NRC STAFF EVALUATION OF THE BAILLY CONSTRUCTION PERMIT EXTENSION REQUEST

NRC STAFF EVALUATION OF THE REQUEST FOR AN EXTENSION OF
CONSTRUCTION PERMIT NO. CPPR-104
FOR THE BAILLY GENERATING STATION, NUCLEAR-1
DOCKET NO. 50-367

FIGURE 1

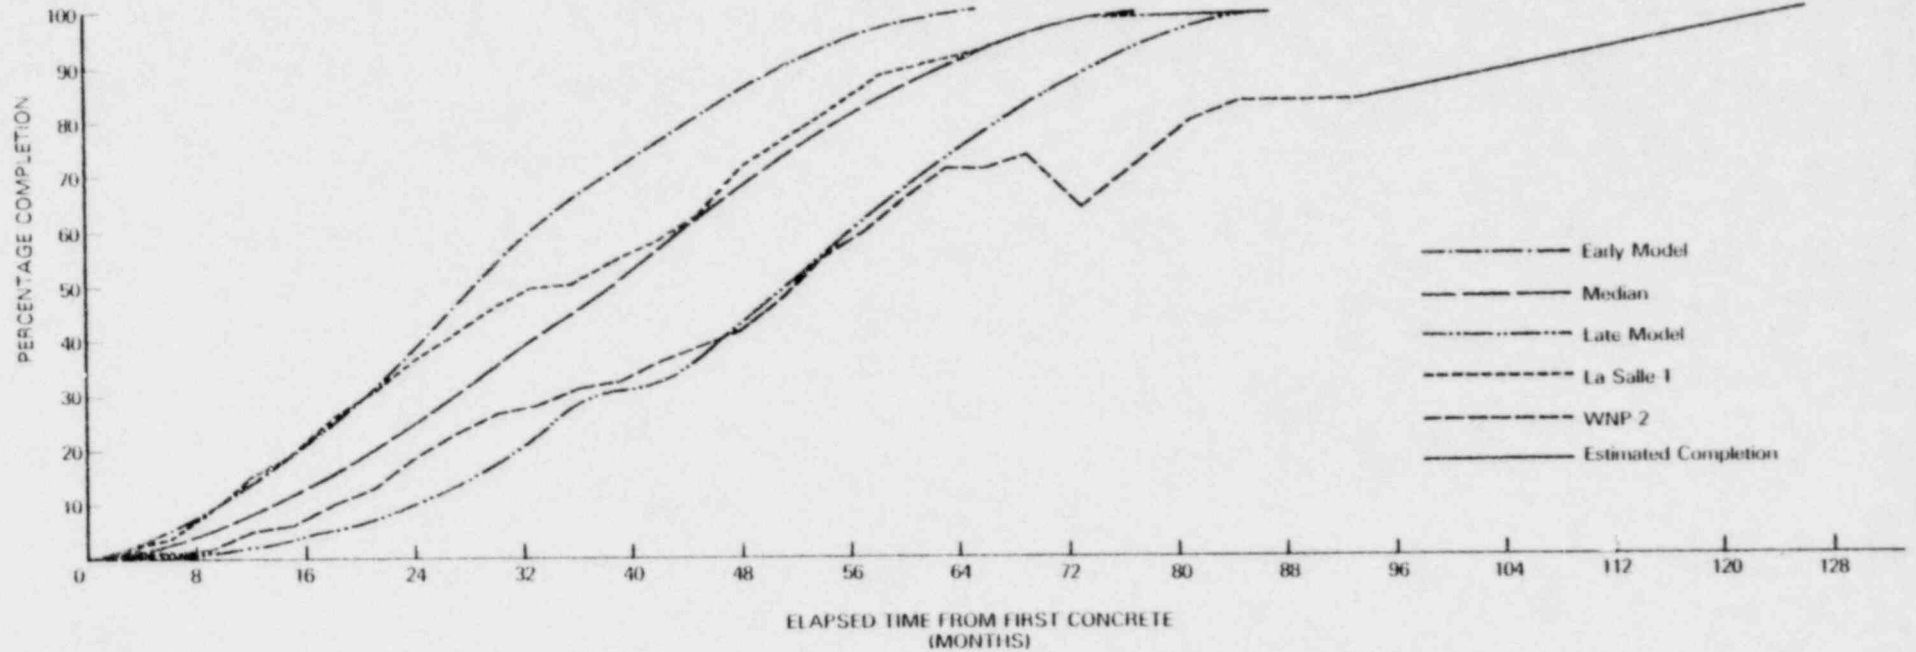
A similar reasoning process applied to the WNP-2 facility indicates that the plant might have been built in 110 months (134 less 24) while the "late" model of the 1979 NRC methodology would predict 102 months (15 months from ground breaking to first concrete plus 87 months from there to completion). Figure 1 supports this reasoning process since the WNP-2 facility closely tracked the "late" construction schedule for about the first five years of its construction. It should be noted that Commonwealth Edison has successfully built and operated a number of plants prior to starting construction of LaSalle-1 whereas the Washington Public Power Supply System (WNP-2) has yet to complete its first facility. The construction schedules of these facilities appear to correlate with the relative experience of their permittees in building nuclear power plants.
